REMARKS

PROPOSED DRAWING REVISIONS

Fig. 3A

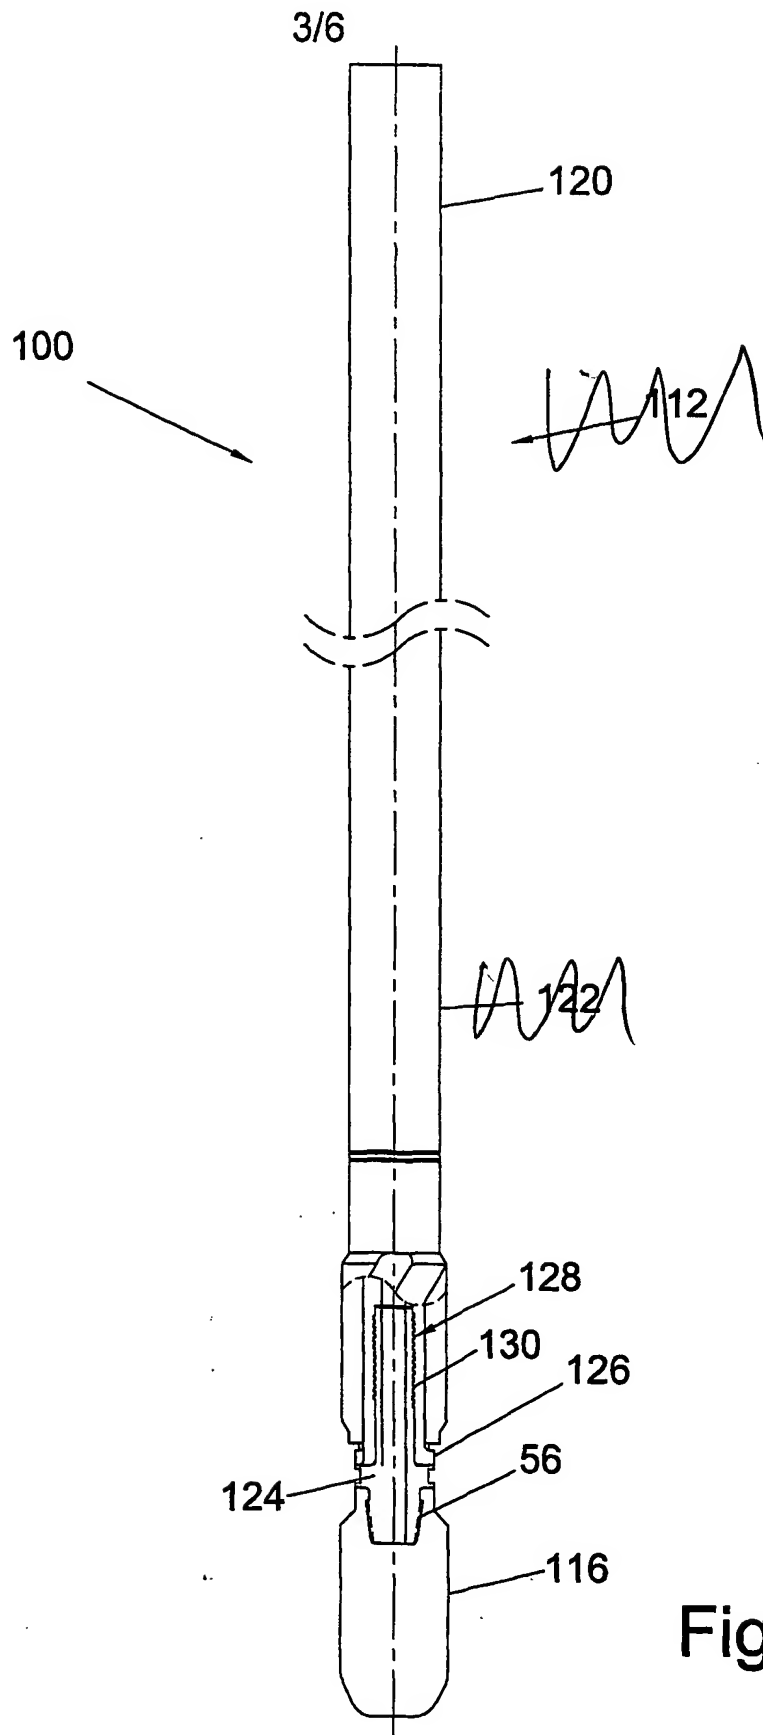
Regarding the objections to the drawings raised by the Examiner in paragraph 3 of the Office Action, Fig. 3 has been amended to remove the reference characters 112 and 122. A marked-up drawing incorporating this change is enclosed for the Examiner's review and approval. As no new matter has been entered, it is believed that this drawing will be approved, so that a formal drawing is also enclosed.
